Transistor Clock 50Hz mod.

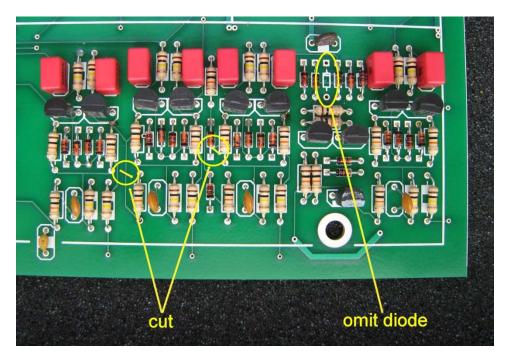
1) Change divide 6 to divide 5:

Top side: two cuts, omit one diode

Underside mods: one cut, three links:-
